Response to Reviewers for “Exploring a lower resolution physics grid in CAM-SE-CSLAM” in consideration for the Journal of Advances in Modeling Earth Systems

General Remarks

10 month average OMEGA500; n120 with C60 topography

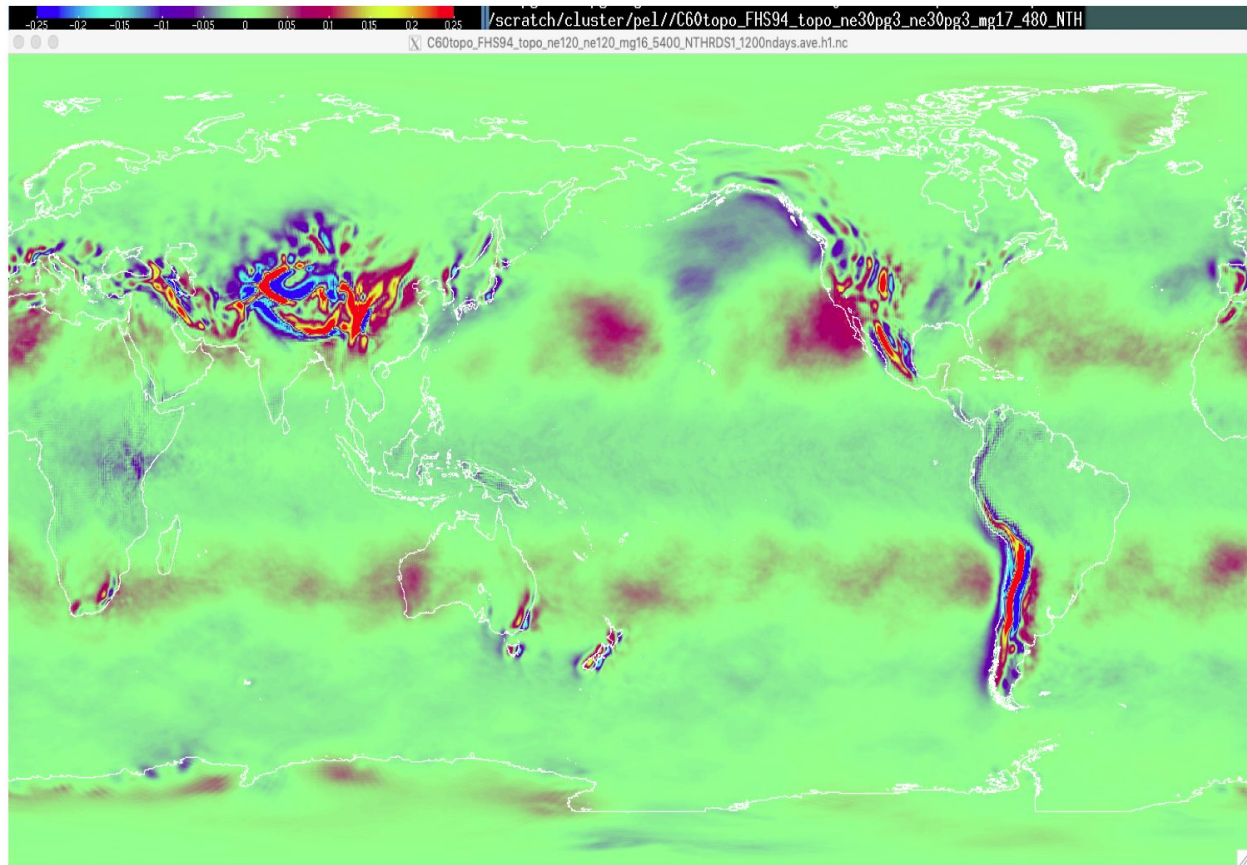
The authors discuss the waves emanating from the Himalayas as grid-imprinting- induced numerical noise. This particular case looks more like the Gibbs phenomenon, which would be induced from the flow around steep topography. Can the authors separate the two issues of Gibbs and grid irregularities and show that the Andes and Himalayas shown are really due to the location of the spectral element boundaries? For example, could one slightly shift the grid so that the element boundary is in a different location but still near the topographic features of interest to see if the waves form in the same location (likely Gibbs) or shift with the boundary (likely grid imprinting)?

It is plausible that waves emanating from the Himalayas are Gibbs ringing. We ultimately decided it would not be worth the effort to shift the grid one node north or south relative to the mountain, to test whether the location of the extrema would line up with an interior node. Our reasoning is that, in the spectral-element method, if you change a value at any node, be it an interior or boundary node, it changes the shape of the basis for the entire element. Had a local max coincided with an interior node instead, gradients near the element boundary would likely steepen in response and an extrema would be introduced there. This tendency for extrema to occur at element boundaries is discussed in detail in Herrington et al 2018 in MWR (in the references of this paper).

Additional experiments using CAM-SE (in which these oscillations are also pronounced), indicate that the oscillations disappear if the flow is sufficiently resolved. Below is a plot of the omega field at 500 hPa in a ne120 simulation, but using the ne30 topography (the smoothing radius of the raw topography is higher at lower resolutions):
